Department of Public Service

4230 Elkhart Road

Location		Structural Inconsistencies		Recommended Corrections/Modifications to Provide Access	Technical Information			Finalized Actions		
Location	Photo	Identified Issue	ADAAG Specification		Priority Ranking and Justification	Improvement Cost	Funding Source	Finalized Correction	Anticipated Date of Completion	Date of Completion

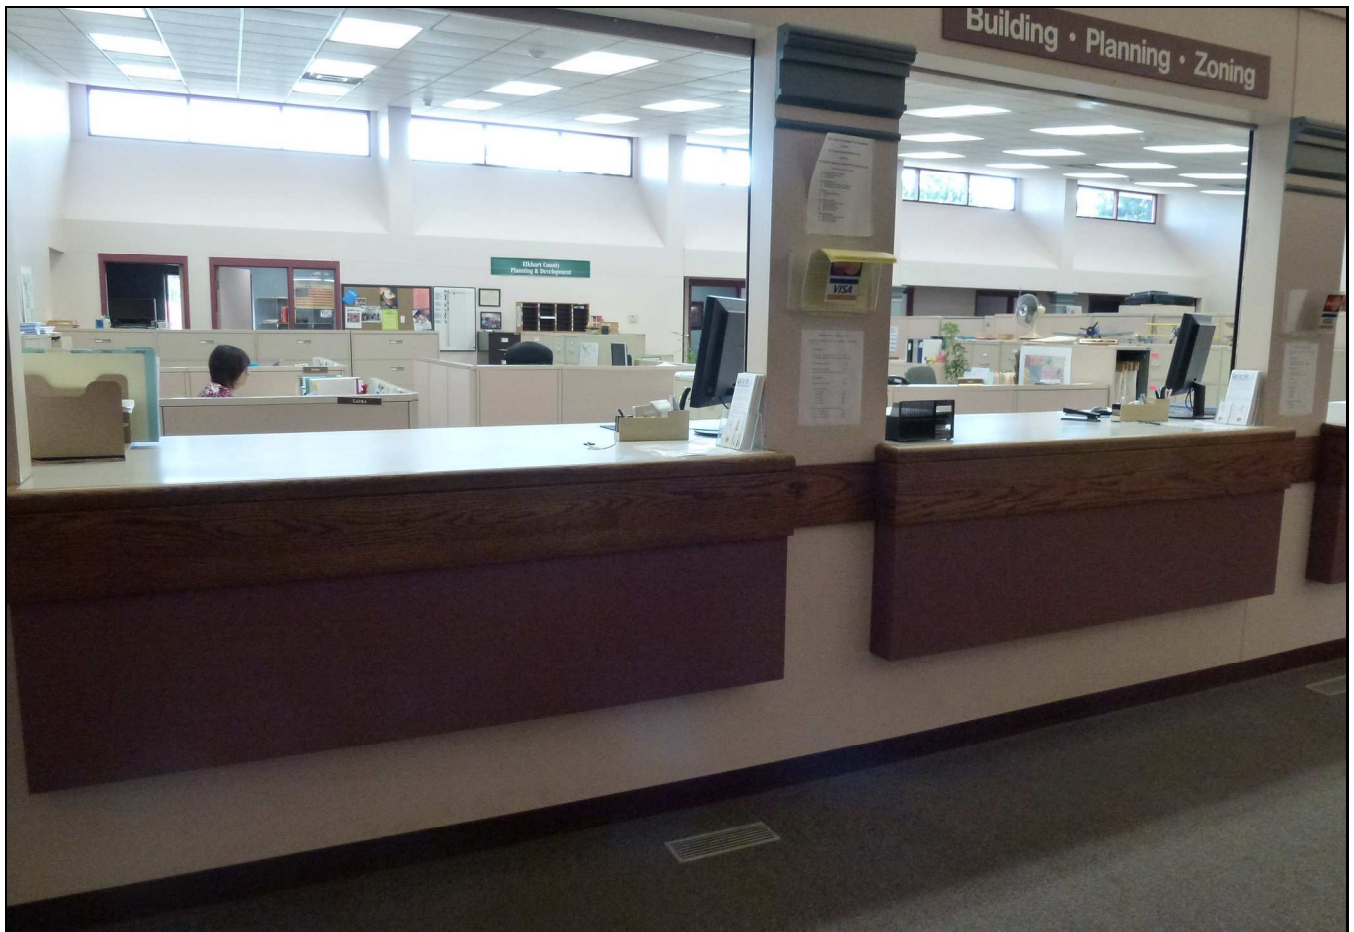
2. Registration Counter	1,2	Registration counter exceeds the maximum height. The counter is 42 1/2" high.	7.2	ADAAG requires sale and service counters to have a maximum height of 36" above the finished floor. <b>Lower portion of counter or provide auxillary counter at 36" height.</b>	<b>M:</b> Everyone entering facility will use this counter. Employee can walk around counter to communicate.	\$8,000	Elkhart County General Fund
